CITY OF PORTLAND, MAINE

AGENDA PORTLAND PLANNING BOARD MEETING

- i. Major Site Plan; 26 E. Oxford Street; 26 Oxford, LLC., Applicant. (estimated time 4:30 – 5:30 p.m.) The Planning Board will hold a remote workshop to consider the development of a four-story, six-unit residential building at 26 East Oxford Street. The subject property is 4,720 square feet in size and is zoned R-6 Residential.

1 Elevation - Cleaves Street
1/4" = 1'-0"

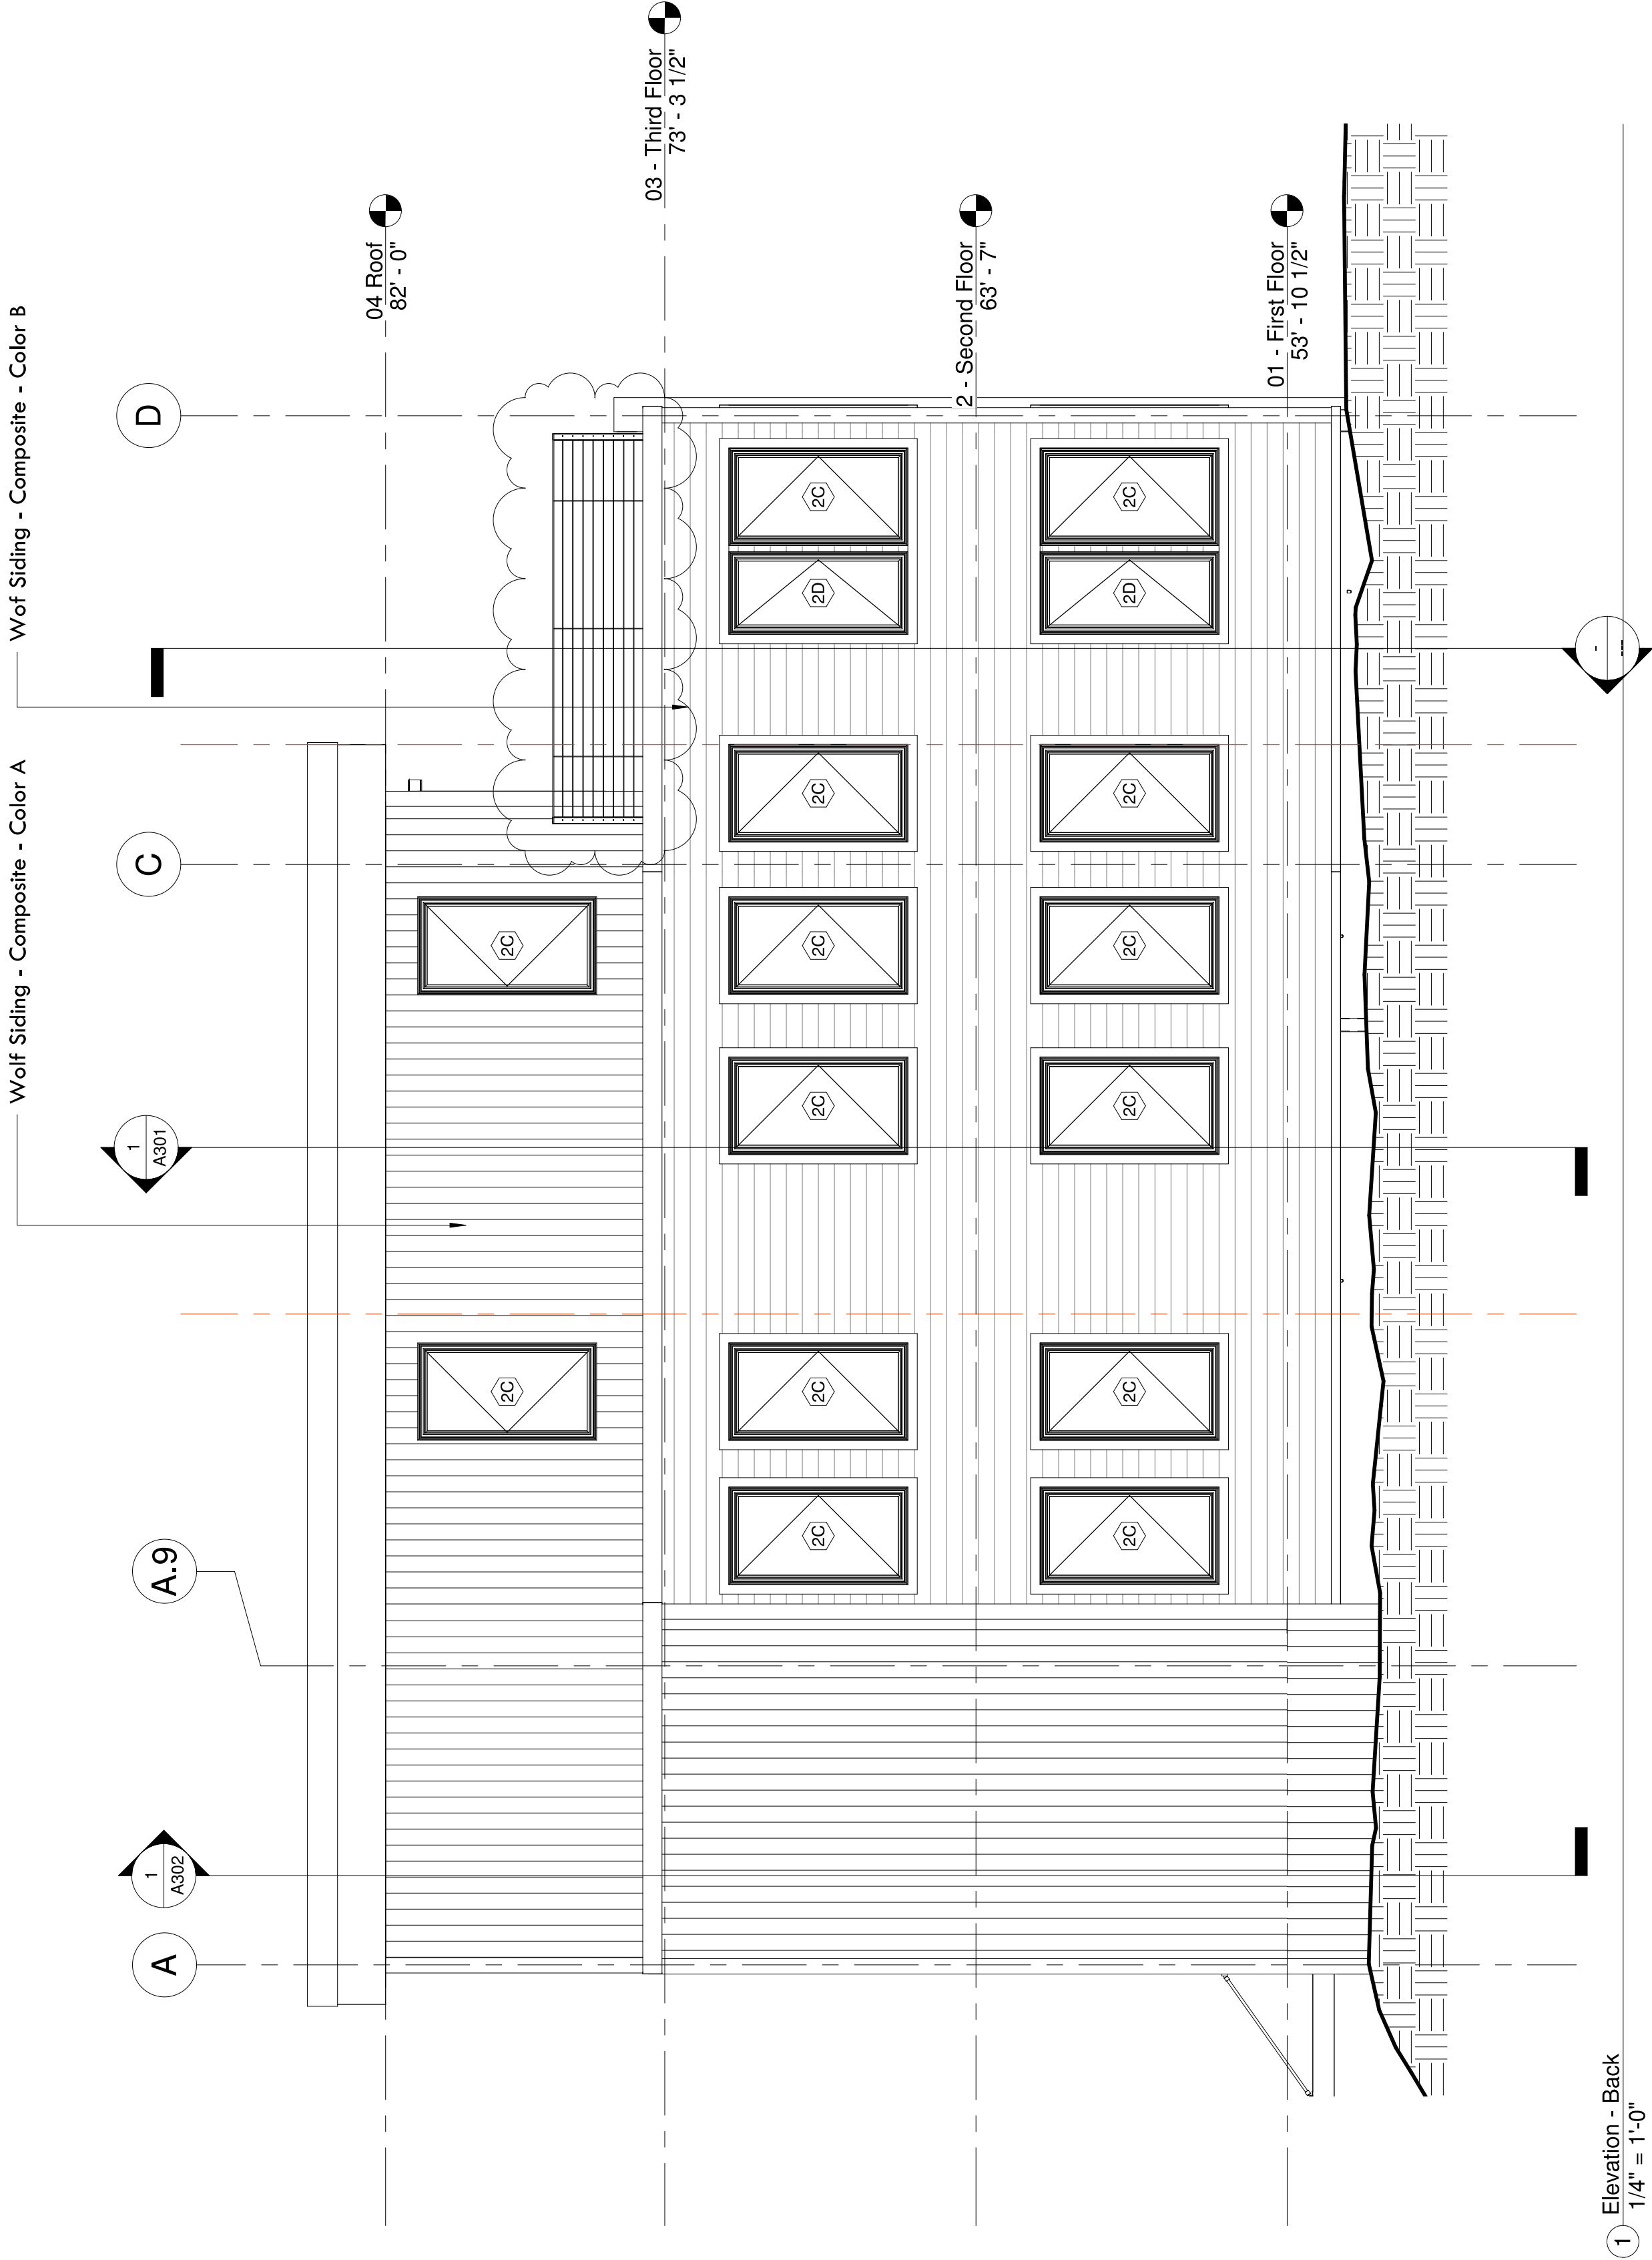
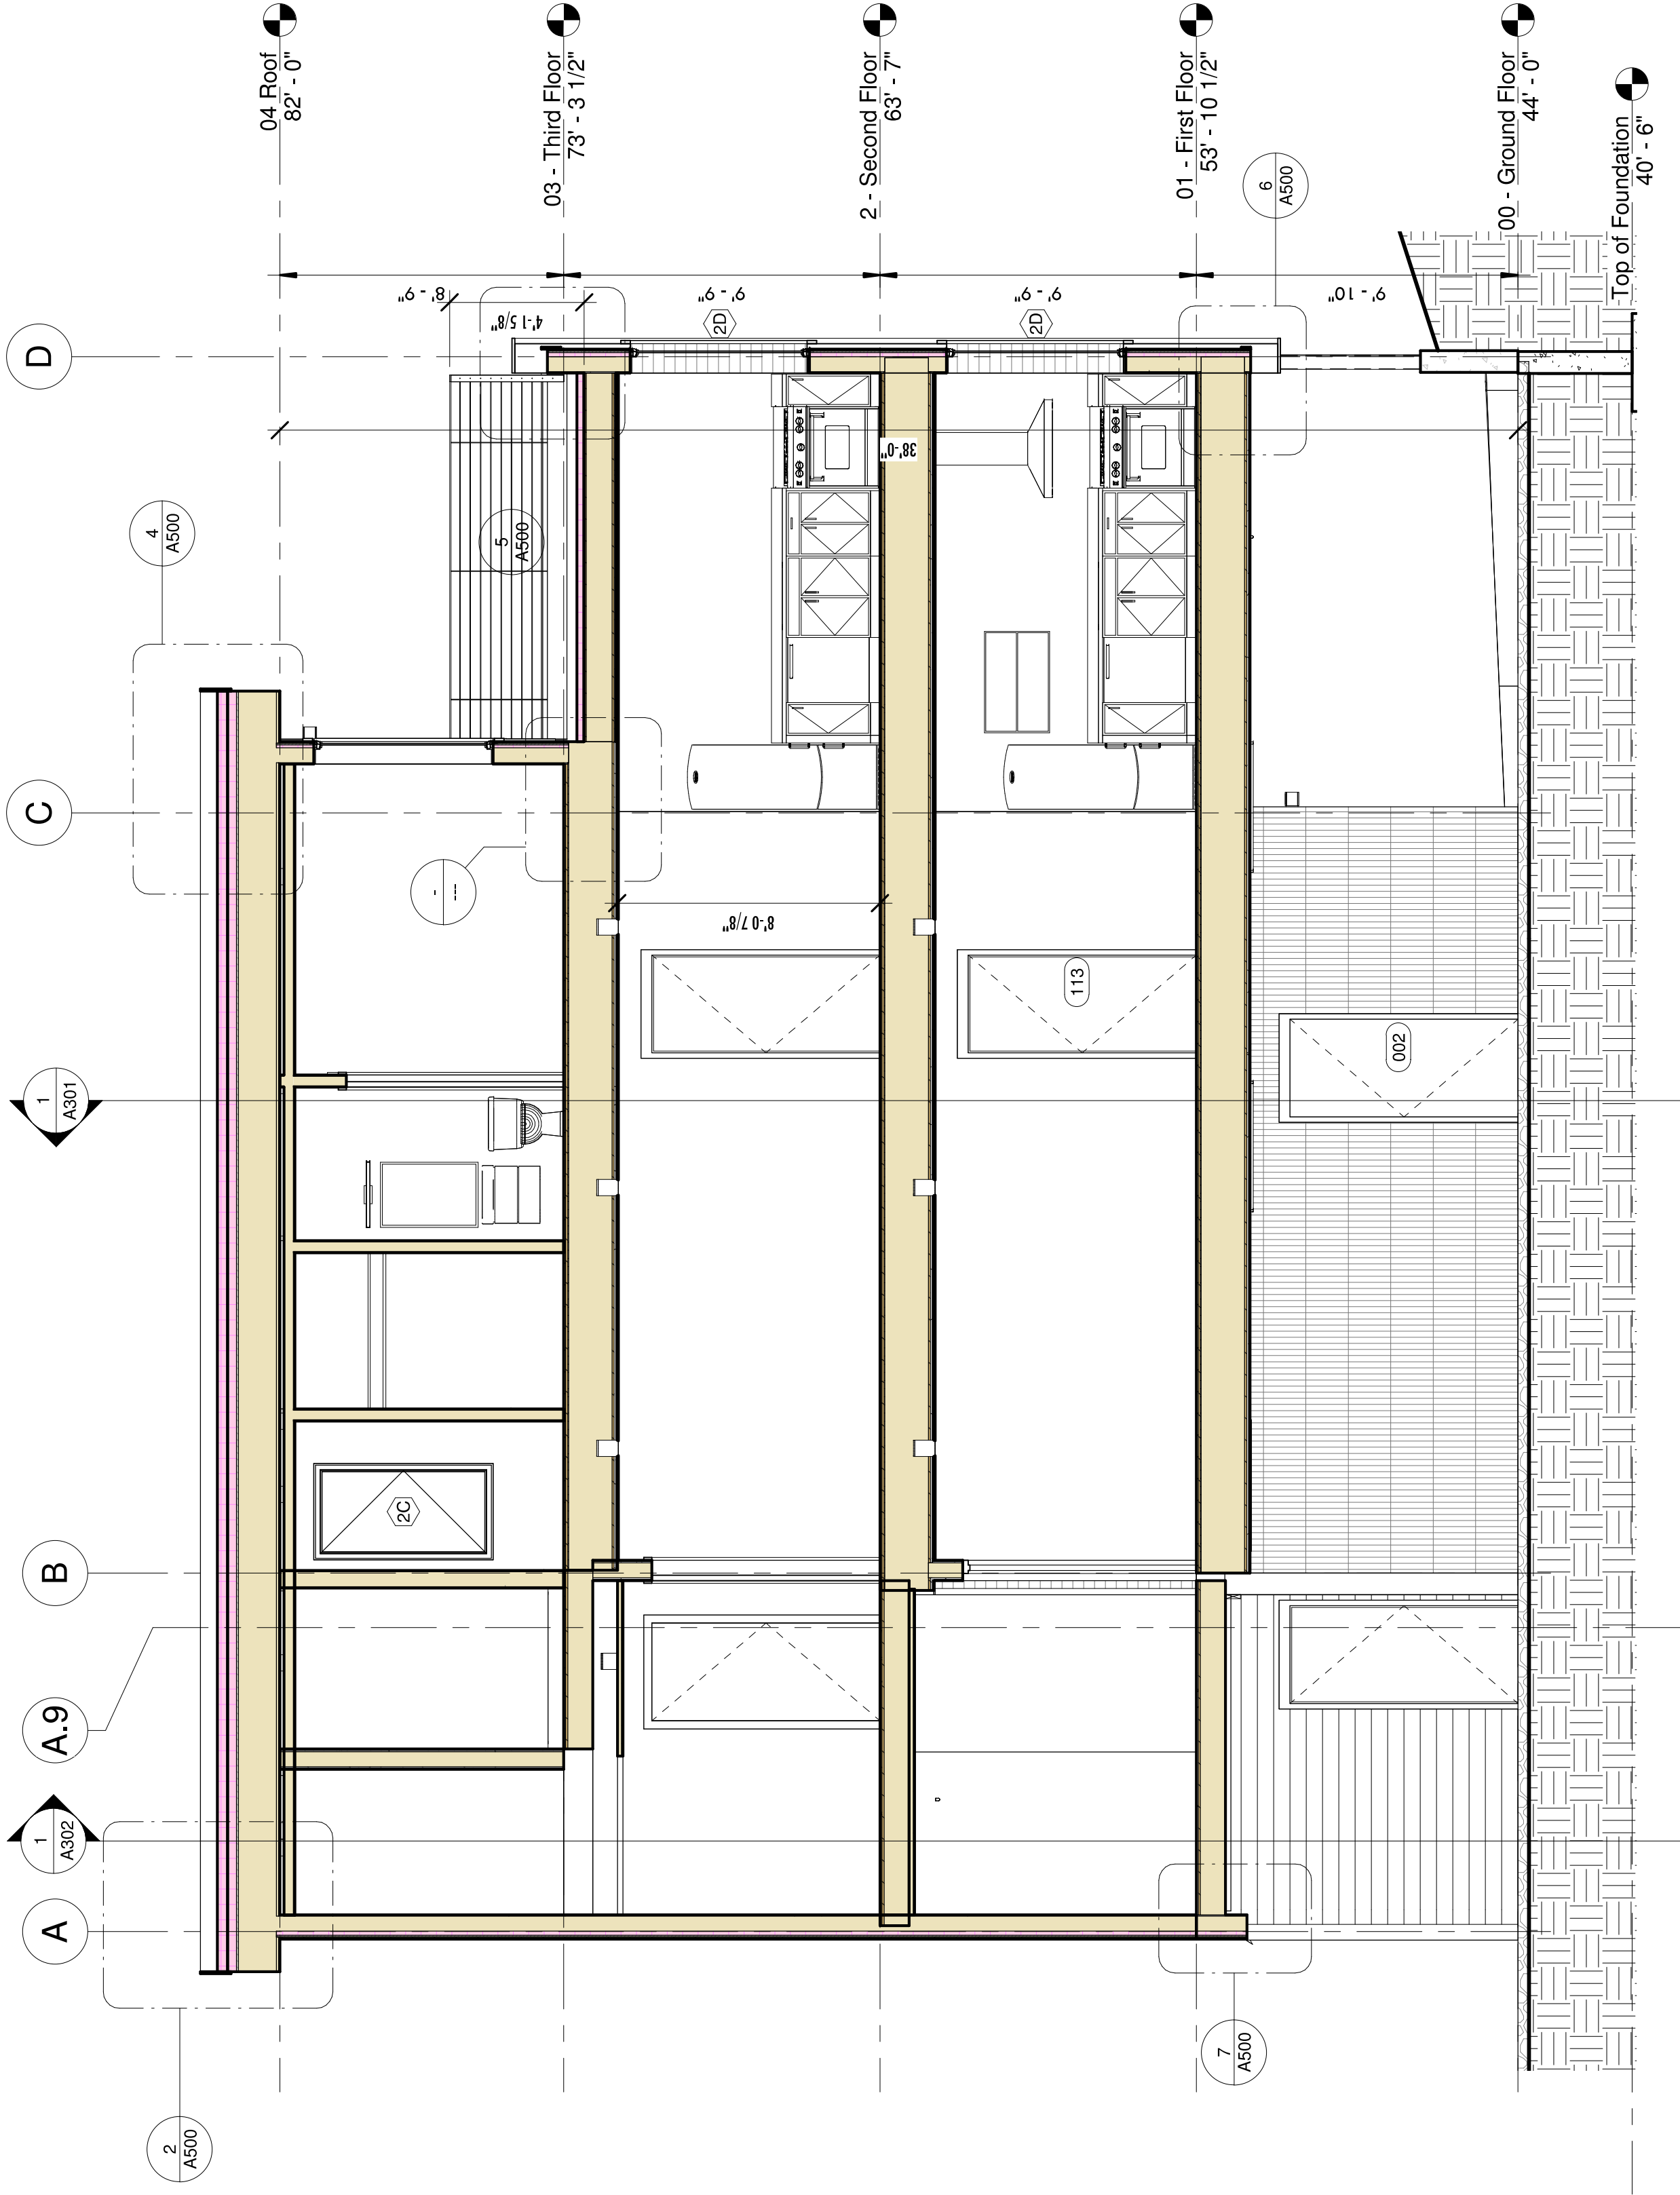
- **Surface articulation in the building should include detailed consistency on the façade visible from the public right of way through dimensional trim (minimum width of 4”), window reveals, or similar elements appropriate to style of building. Clarify material type of proposed trim and details on the façade for windows and exterior doors facing street.**

- **Vinyl siding, as proposed as the predominant façade material, is not appropriate for the multi-residential building to be compatible with the neighborhood. Applicant to explore clapboard material and clarify type and color.**

A proposed composite siding is proposed with a variety of reveal and color to provide a durable and aesthetic façade.
